**MAJOR SUBDIVISION 6 LOT SKETCH PLAN**

Reference: Klimenko Major Subdivision Plan, Sketch Plan Review 1  
80 Curley Mill Road, T.M.P. #26-001-090-001

Pursuant to your request, Gilmore & Associates, Inc. has completed a formal Sketch Plan review of the referenced plan which focused on the Township's Zoning Ordinance and a cursory review of the Subdivision and Land Development Ordinance (SALDO). We offer the following comments for consideration by New Britain Township:

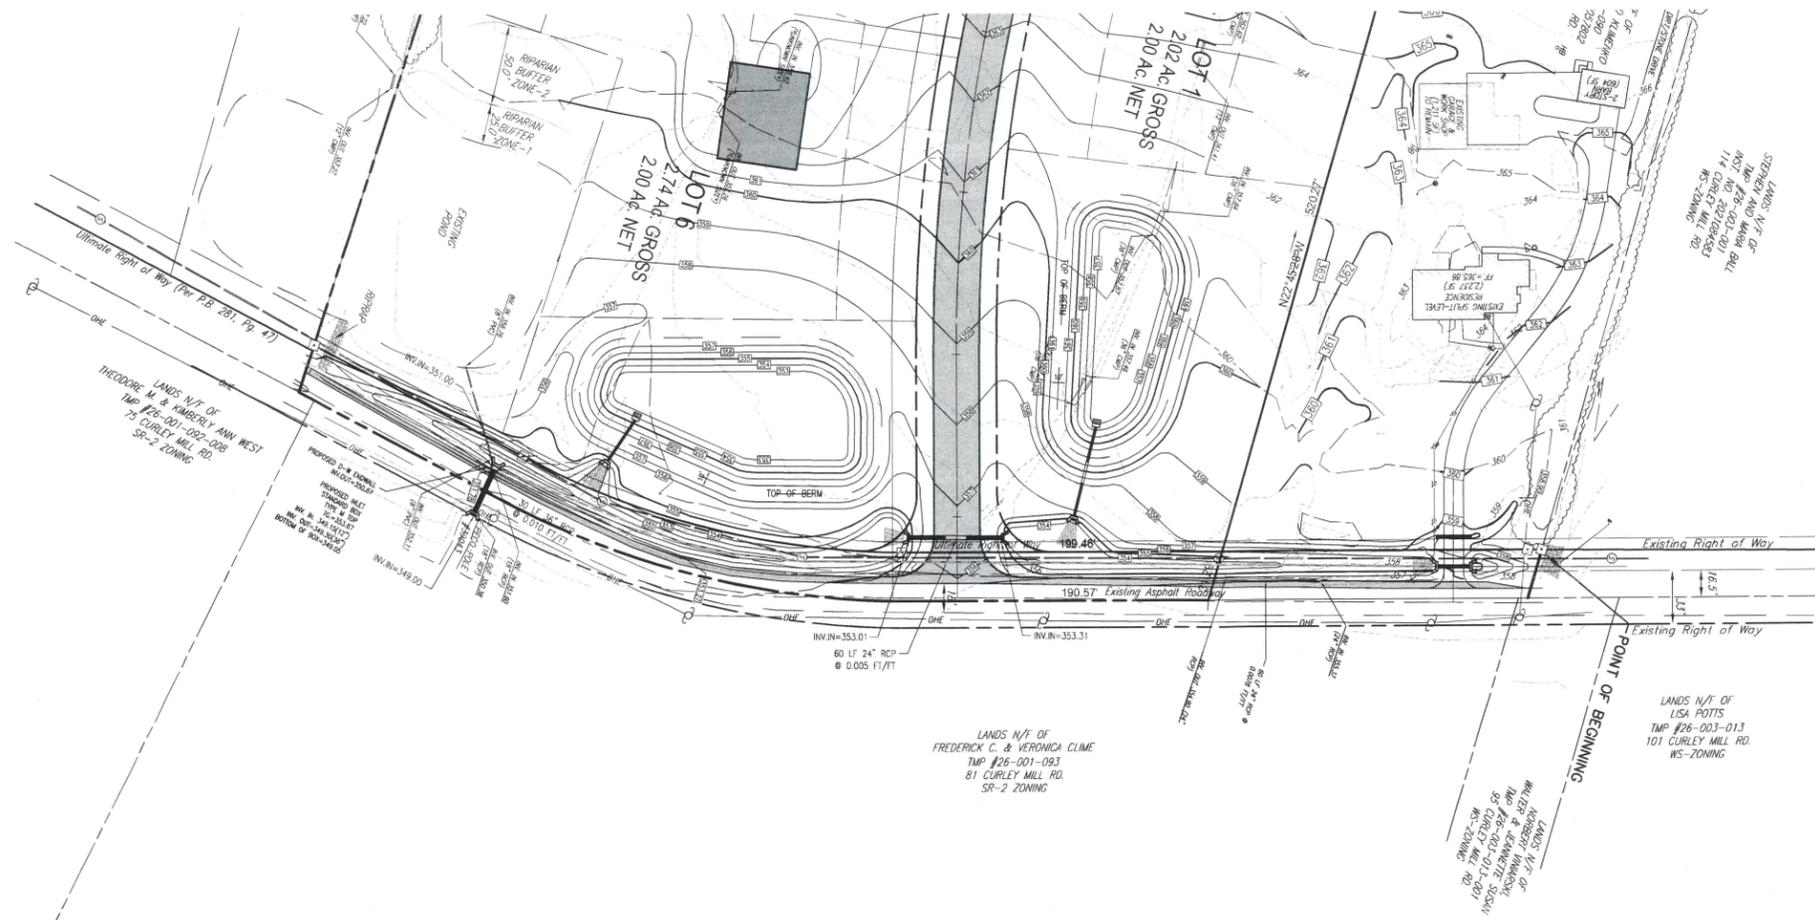
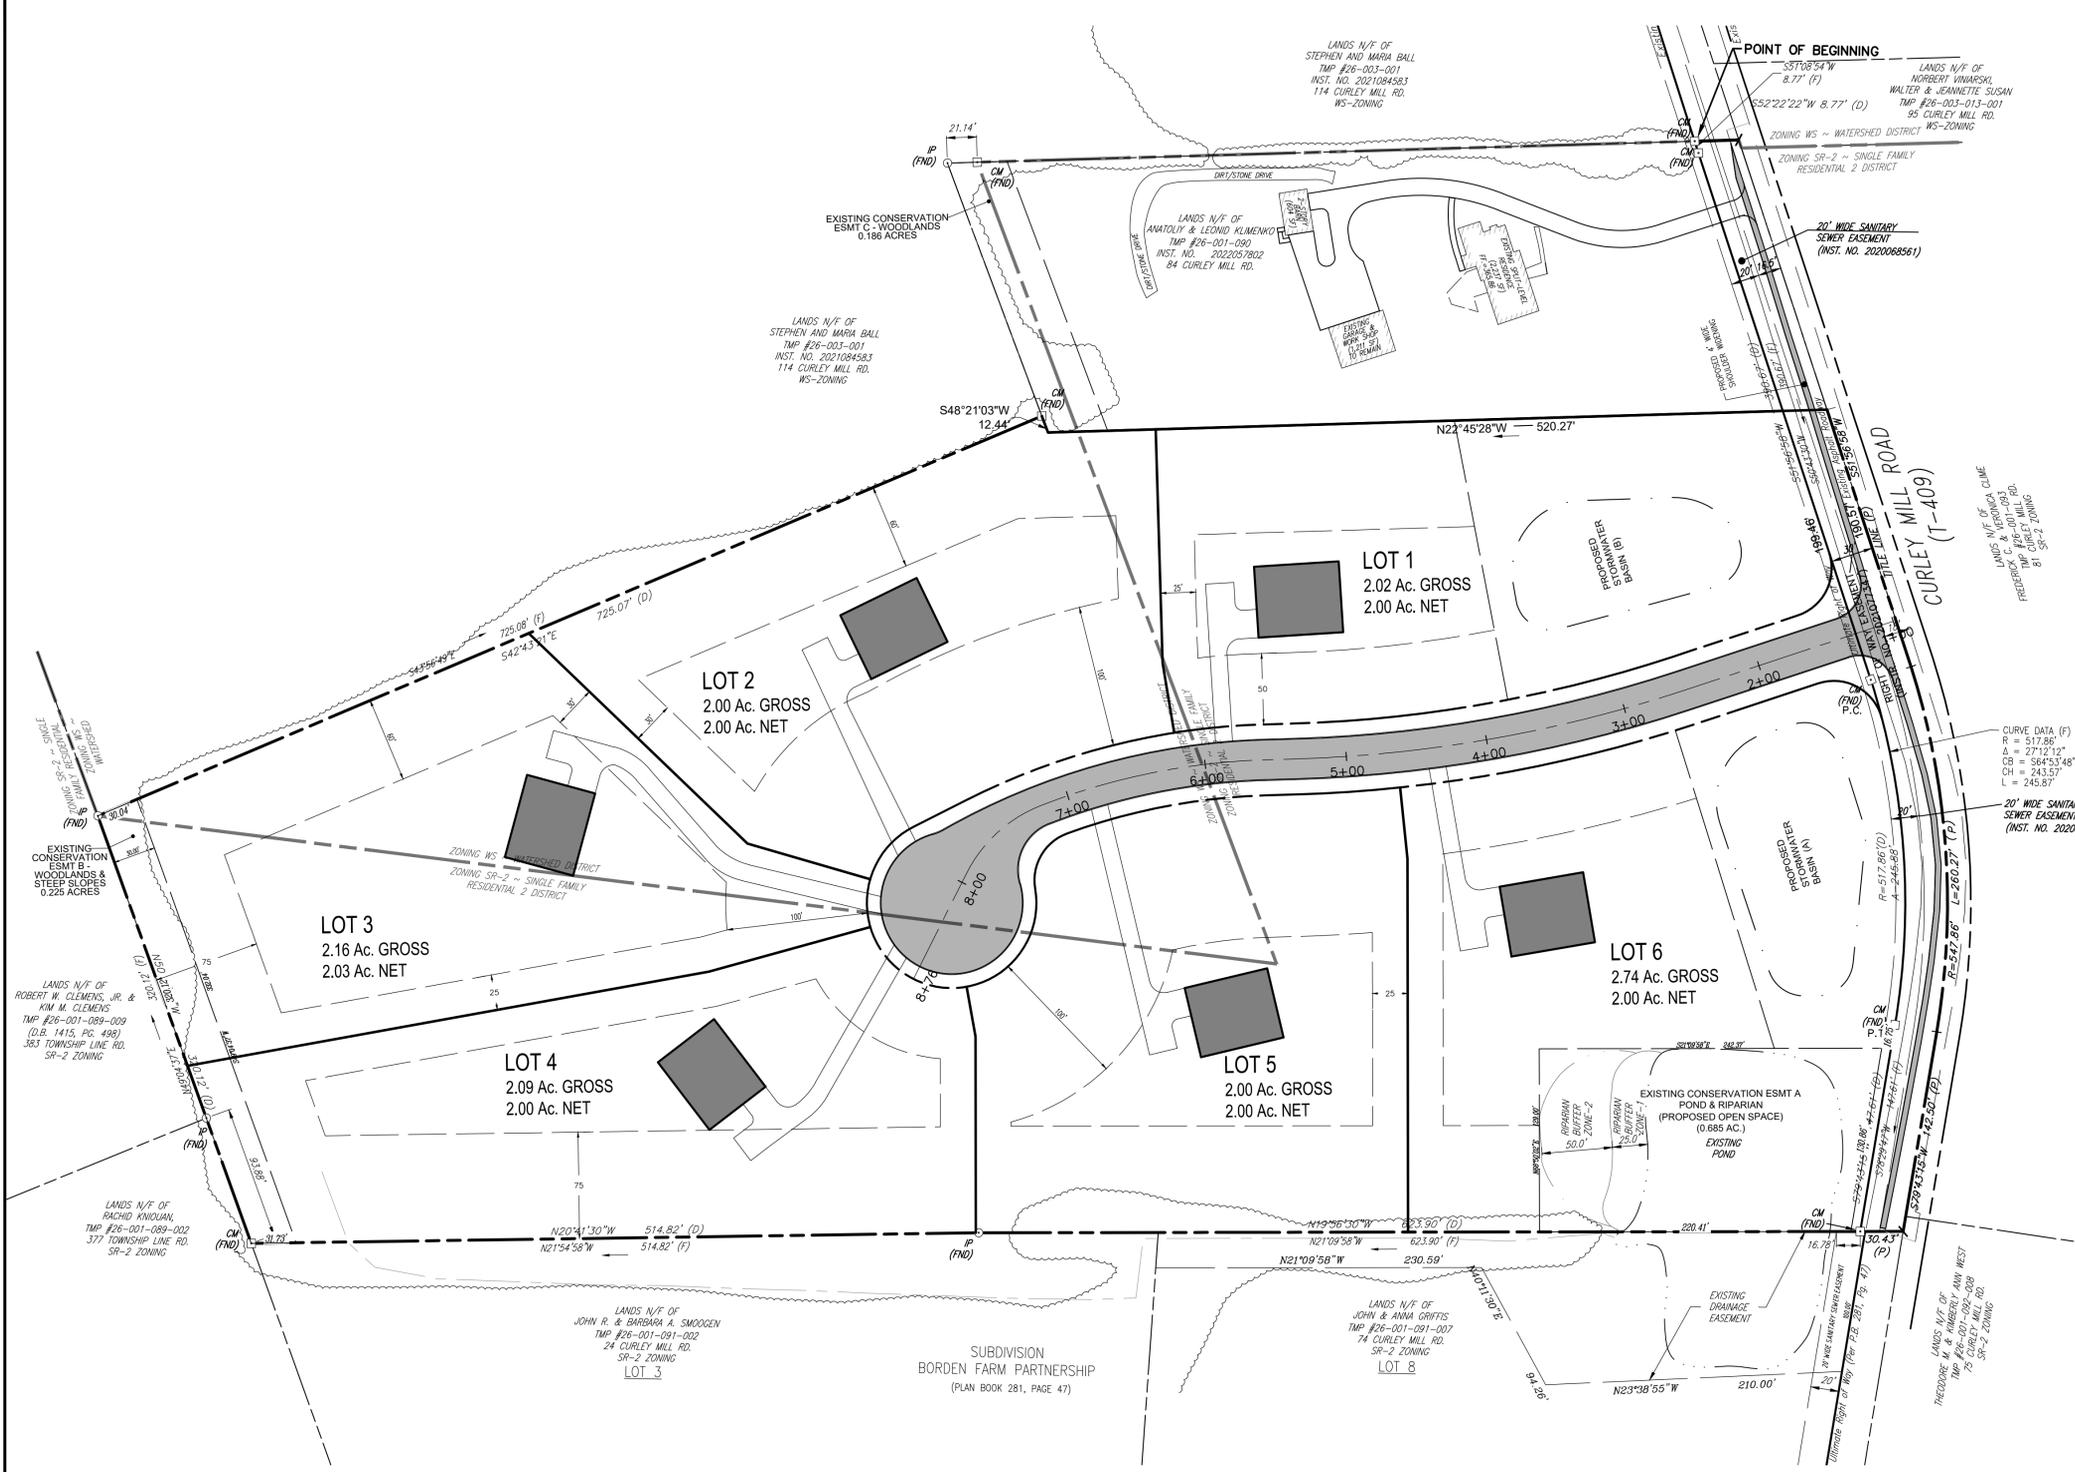
1. §27-106.c. – As noted, the site is split-zoned and with the proposed layout, Lots 2, 3 and 5 will be split-zoned. We recommend a zoning map amendment be processed prior to the development of the site for consistent zoning requirements throughout the development. Since the majority of the site is in the SR-2 Zoning District, we recommend the Watershed WS Zoning District area be amended to the SR-2 Zoning District. This would also result in shorter driveways and therefore, less impervious, and more area behind the dwellings for future improvements by the homeowners.

2. §27-502.b.1.(h)2) & §27-802.b – The maximum impervious surface ratio “per site” in the Watershed District is 12% and the maximum impervious surface ratio “per site” in the SR-2 District is 20%. The Impervious Surface Summary table notes a total site impervious area of 100,290 s.f. and a total site impervious area of 20.1%. We offer the following comments related to the impervious coverage:

- a. If not rezoned, the impervious calculations shall be revised to show the maximum impervious cover permitted per each zoning district, and the site and future impervious values shall not exceed the maximum impervious ratio for each district.

- b. The maximum impervious surface ratio for a *lot* in the SR-2 District is 25%. The Impervious Surface Summary table specifies a maximum impervious surface ratio of 20% for Lots 1 and 6 and a maximum of 13.1% for Lot 4 due to the 20% maximum impervious surface ratio for the entire site which includes the new street. If the lots are split-zoned, a seller’s disclosure statement will be required to specify the maximum impervious surface areas to the prospective buyers.

4. §27-802.b – In the SR-2 District, lots shall have a minimum width of 200 feet at the minimum required building setback line. It appears Lots 3 (split-zoned) and 4 (SR-2) have a lot width of less than 200 feet. The minimum lot widths shall be provided as specified in Section §27-201.Lot.h.Lot Width, and the required lot width should be dimensioned on the plan. In no case shall the lot width between the site lot lines at any location be less than 2/3 (66%) of the minimum required lot width.

5. §22-703.4.A(4) – The depth of any proposed lot shall not exceed three times its width. The depth of Lot 3 is estimated to be four times the width based on the current layout.

6. §22-703.4.C – Lot lines shall be drawn parallel, concentric, at right angles or radial from the street right-of-way line. All lot lines are drawn perpendicular to or radial from the proposed right-of-way line then change direction. The lot lines shall be extended to at least the building setback lines before any horizontal changes in direction.

**CONCEPTUAL STORMWATER & ROAD IMPROVEMENTS**

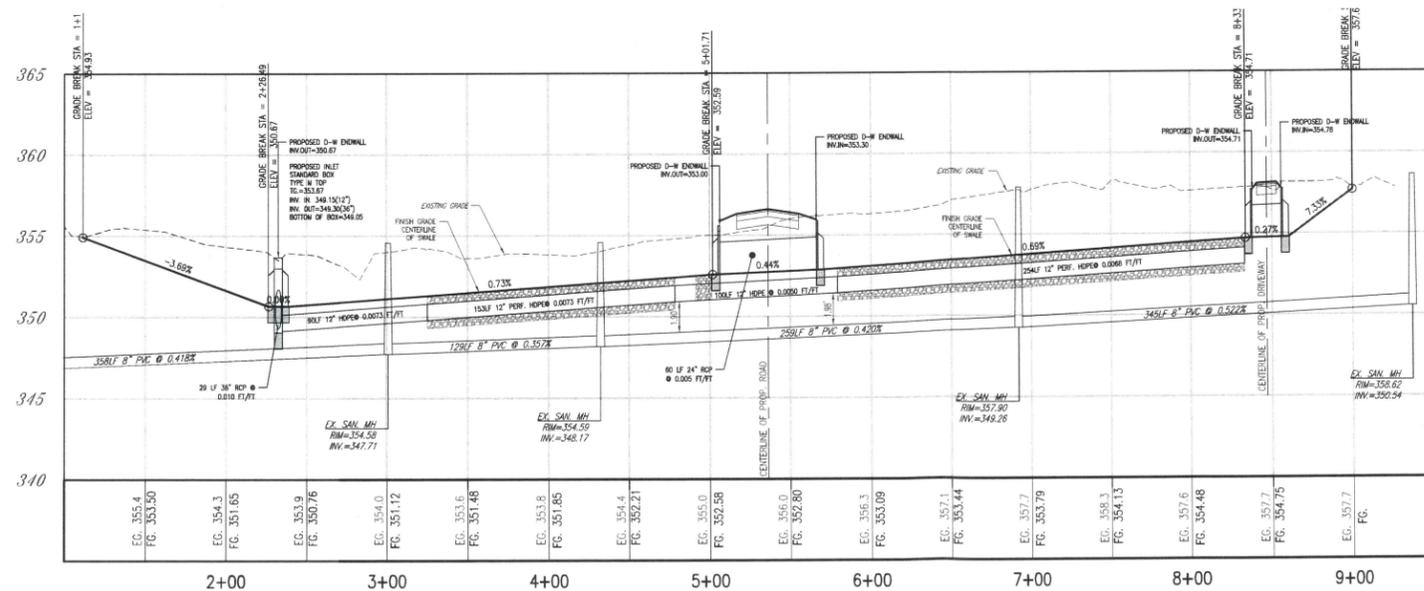
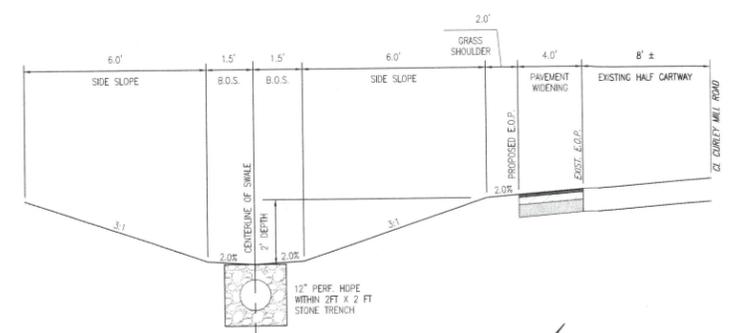
- a. The plan proposes the required 30-foot-wide half width ultimate right-of-way and proposes widening the existing 8-foot-wide travel lane by 4 feet where 10 feet of widening is required. We note that 4-foot widening is consistent with the adjoining Borden Farm Subdivision. However, the grass shoulder for the Borden Farms subdivision was approved with a 4-foot grass shoulder where a 2-foot grass shoulder is currently proposed.

- b. We note that the “Conceptual Stormwater and Road Improvements” plan included with the Sketch Plan proposes a 0.7% slope swale with a 12” diameter underdrain along the frontage of Curley Mill Road and replacement of the existing 18” concrete cross pipe under Curley Mill Road with a 36” concrete pipe.
